SUBJECT: Consideration and Action Regarding a Variance Request for Driveway Serving the Proposed Fire Station No. 1 and Fire Administration

EXHIBIT A
Driveway width
variance exhibit

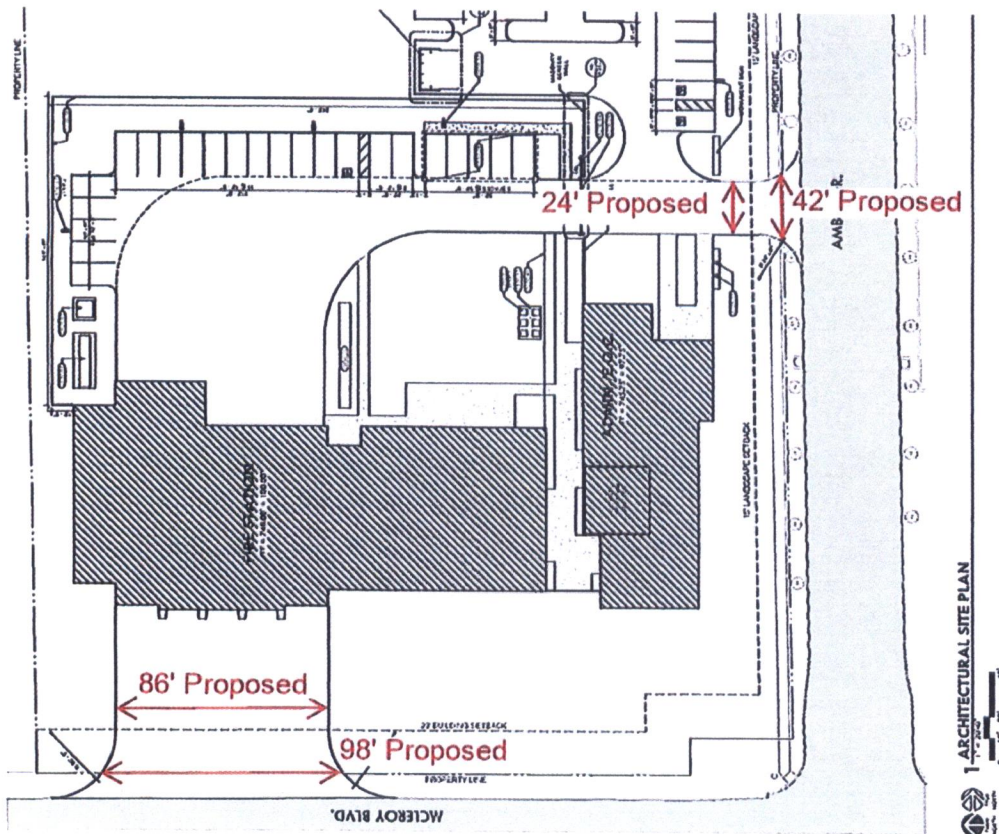
Staff is recommending a variance to the maximum driveway width of thirty-five feet (35') for two (2) industrial/commercial driveways for Fire Station No. 1 and Fire Administration project.

Article 9 – Construction Standard Details, detail RD-12 (attached) shows a maximum width of thirty-five (35') for non-residential driveways measured at the throat of the driveway. The fire station design calls for a driveway width at the throat of eighty-six feet (86') on W. McLeroy Blvd. The proposed width of the driveway on Amber Dr. at the throat is twenty-four feet (24') on Amber Dr.

Article 7 – Design Criteria, Section 7.08 – Streets, G – Driveway Requirements, Par. 5, limits commercial and industrial approaches to a maximum of thirty-five feet (35') measured at the property line. The proposed driveway approach on W. McLeroy Blvd. measured at the property line is approximately ninety-eight feet (98'). The proposed driveway on Amber Dr. is approximately forty-two feet (42').
